Proposed Development of Wingecarribee
Animal Shelter + SES Facilities at
1 Bowman Road, Moss Vale, NSW

s. 4.55(2) Application

STATEMENT OF ENVIRONMENTAL EFFECTS

June 2023

Figure 15A: Site Stormwater Plan – s.4.55 Modification (source: JN Responsive Engineering)

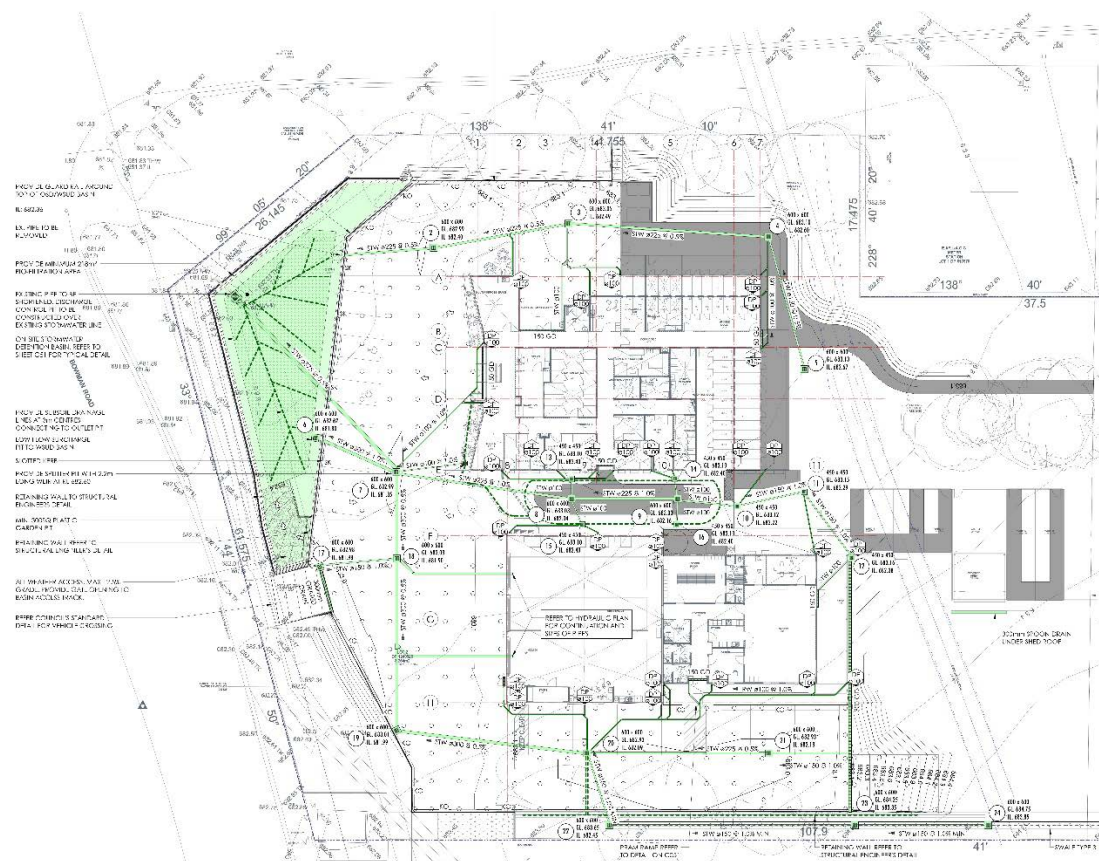
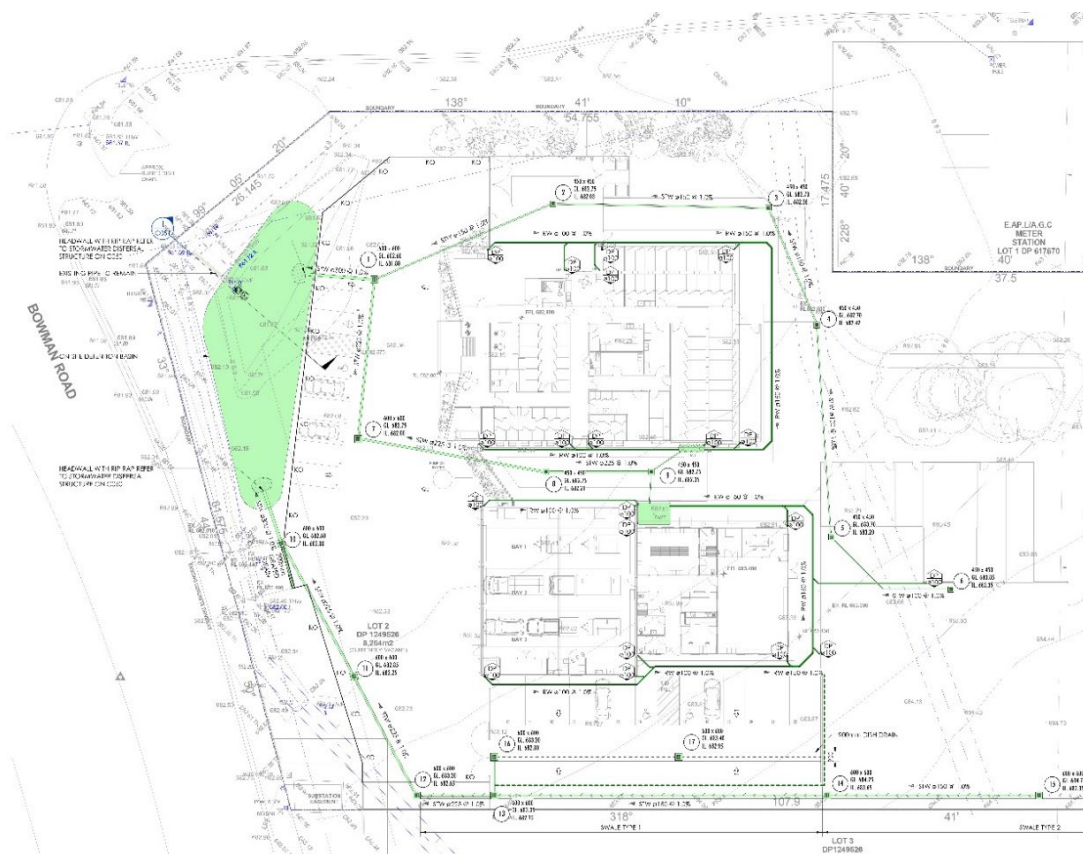
- Refinements and modifications to civil works/ stormwater design to suit a bio-filtration basin and altered building levels.

- Provision of battered sides to the on-site detention (OSD) basin north-east of the car parking area to omit the need for balustrade – at the corner of Bowman Road and Berrima Road.
- Refinements and modifications to civilworks/ stormwater design to suit the proposed of lowering of Ground Floor level of SES building, comprising relocated pits and recalculation of on-site detention (OSD).

Figure 16A: Amendment to front façade – s.4.55 Modification

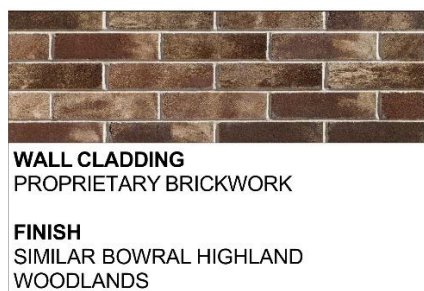
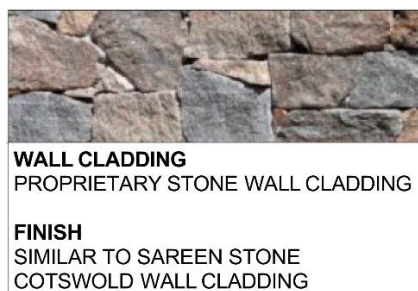
The front façade of the Animal Shelter building is amended from stone to be of a brown face brick colour – **COMPLIES** (Figures 16A & 16B) No changes, otherwise, to the external colours of the proposed buildings.
